BCA & Access Assessment Report

Lot 3, Horsley Logistic Park
3 Johnston Crescent, Horsley Park

Prepared for:
ESR Australia

Revision 1
31 July, 2024
Reference: S240183

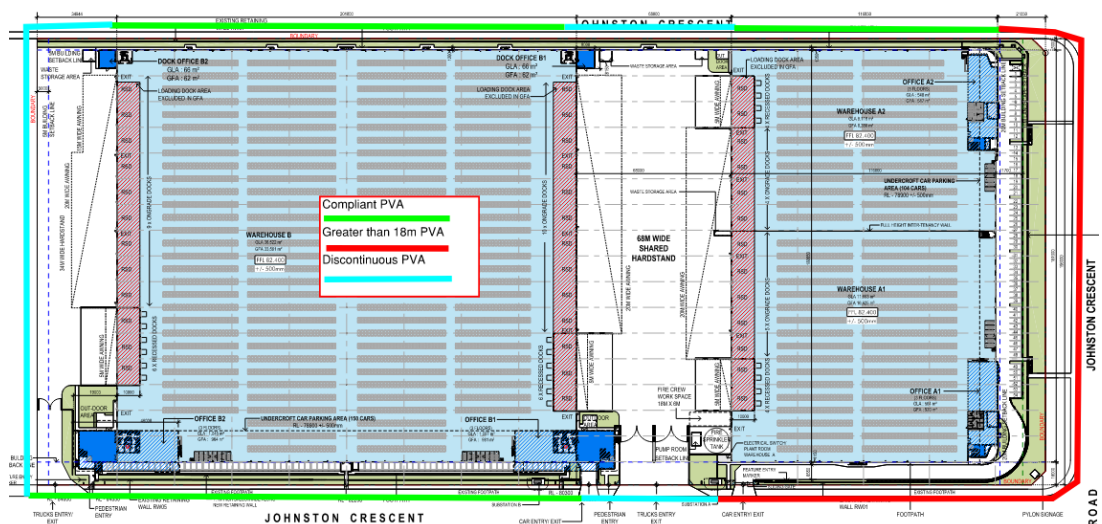
Comment: Both warehouses have non-compliant perimeter vehicular access. A performance solution will be required to allow the following non-compliances:

- To allow perimeter vehicular access greater than 18m along the northern and eastern end of Warehouse A.
- To allow discontinuous perimeter vehicular access.

Office A1 Pedestrian Entry from Accessible Parking Space (Image on left):

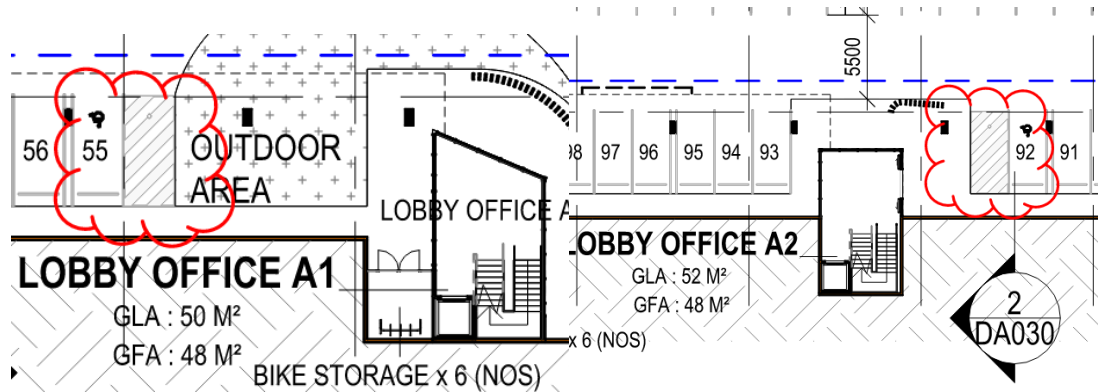
A compliant access path is required from the accessible car parking spaces from each office lobby area. The following excerpts have been flagged as no reference levels have been provided to identify whether the parking spaces and footpath are on the same grade or whether a ramp may be proposed. Provided further detail to illustrate that compliant access to the lift lobby is achieved from the accessible parking space.
